UNITED STATES PATENT AND TRADEMARK OFFICE

APPLICATION NO.	FILING DATE	FIRST NAMED INVENTOR	ATTORNEY DOCKET NO.	CONFIRMATION NO.
10/786,787	02/24/2004	Huikai Xie	5853-345	3761
30448	7590	09/21/2005	EXAMINER	
AKERMAN SENTERFITT P.O. BOX 3188 WEST PALM BEACH, FL 33402-3188			HANLEY, JOHN C	
			ART UNIT	PAPER NUMBER
			2856

Office Action Summary

DETAILED ACTION

Figure 6-38: SEM of a released 6-DOF IMU.

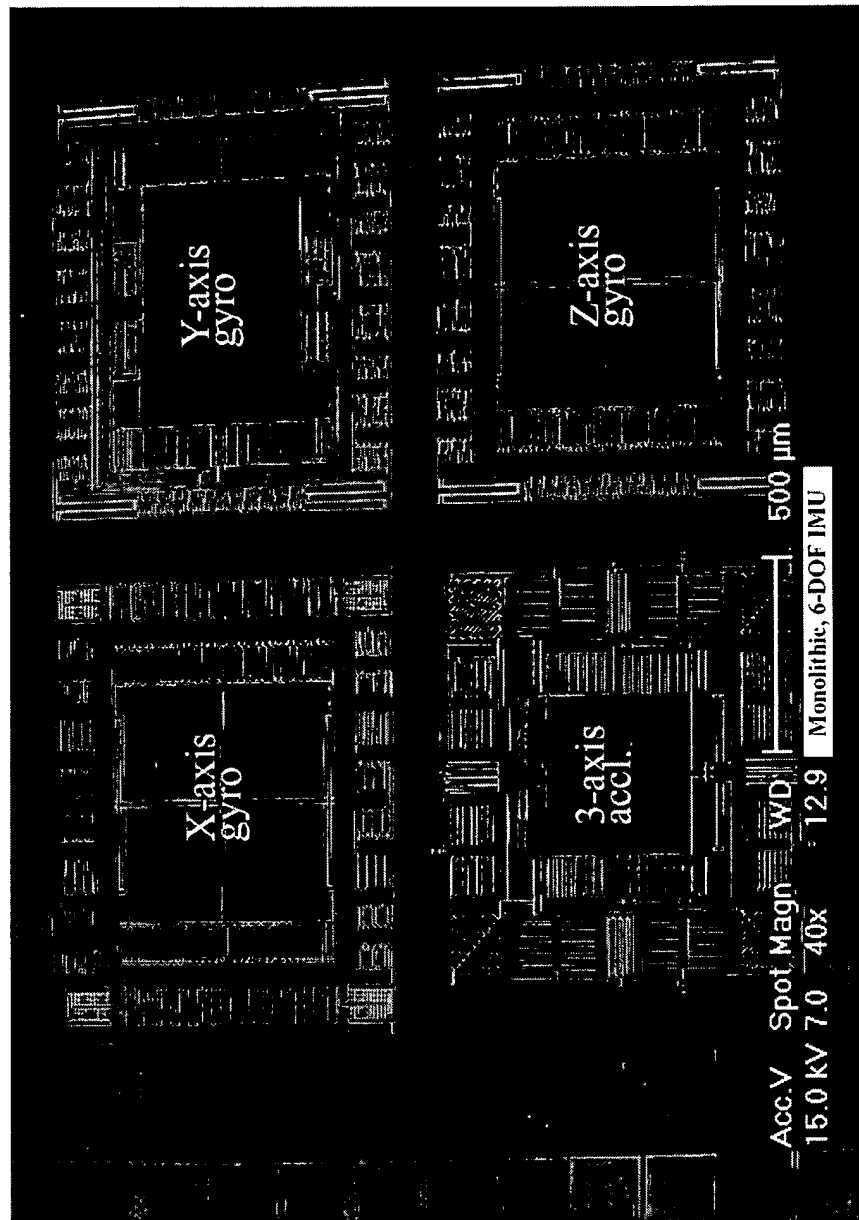
Figure 6-38 on page 194 of the thesis, taken in conjunction with the text of the thesis, clearly shows a three-axis accelerometer chip having a plurality of comb finger sets with one set for each of three orthogonal axes, where all are on a membrane layer portion of a single crystal substrate, and a proof mass support by at least one flexure, with comb fingers on the proof mass, where the flexure connects the proof mass to the membrane. A pre-amplifier is shown on-chip in Figure 6-24 on page 126. The comb finger sets provide fully differential capacitive bridges for all axes, and are formed of metal/dielectric stacks disposed on the membrane layer, where the metal may be electrically connected or isolated from the membrane layer, with the membrane layer having a smaller cross-section than the metal area of the fingers (Figure 3-20, page 51; and Figure 6-37, page 194). The structure for Z-axis sensing is spring decoupled from a rigid frame used for supporting comb fingers for x- and y-axis sensing. The membrane layer is further taught as being less than 100um thick on page 18.

9. If not anticipated by the text and Figure 6-38 of Reference W, it would have been clearly obvious to one of ordinary skill in the art to take the technology presented with respect to the gyroscope structure and apply it to the fabrication of a 3-axis accelerometer as shown in Figure 6-38 and page 194 of the thesis text.

10. Applicant's remarks have been read and considered, but are unpersuasive. Applicant's argument that no details can be discerned by the very poor copy of Figure 6-38 is not well received, since a similar copy made by the Examiner, and attached to this action, clearly shows the same structure as shown by applicant's Figure 7A that applicant relies upon to describe the invention, and the poorly printed copy supplied by the Examiner is no where as clear as the same figure from which it was copied. In this figure, it is clearly obvious to one of ordinary skill in the art, that there is a proof mass in the middle supported by flexures, for example, in the corners, and a plurality of sets of comb fingers for sensing motions. One of ordinary skill in the art, having read this thesis, would clearly recognize these as capacitive comb fingers. Applicant's argument that the thesis is primarily directed to gyroscopes and not accelerometers is similarly unpersuasive, since the paper does mention and show a 3-axis accelerometer. Further, gyroscopes and accelerometers are not so different as to render one skilled in the art of gyroscopes, as shown in the thesis, incapable of applying the same structural built technology presented in the thesis to EACH axis of a three-axis accelerometer. Applicant further admits in his original paragraph [0054] that those having ordinary skill in the art will appreciate that the structure for x-y sensing can be disposed inside the frame. Thus, applicant recognizes the ability of one of ordinary skill in the art to arrange the elements with respect to one another to sense the appropriate
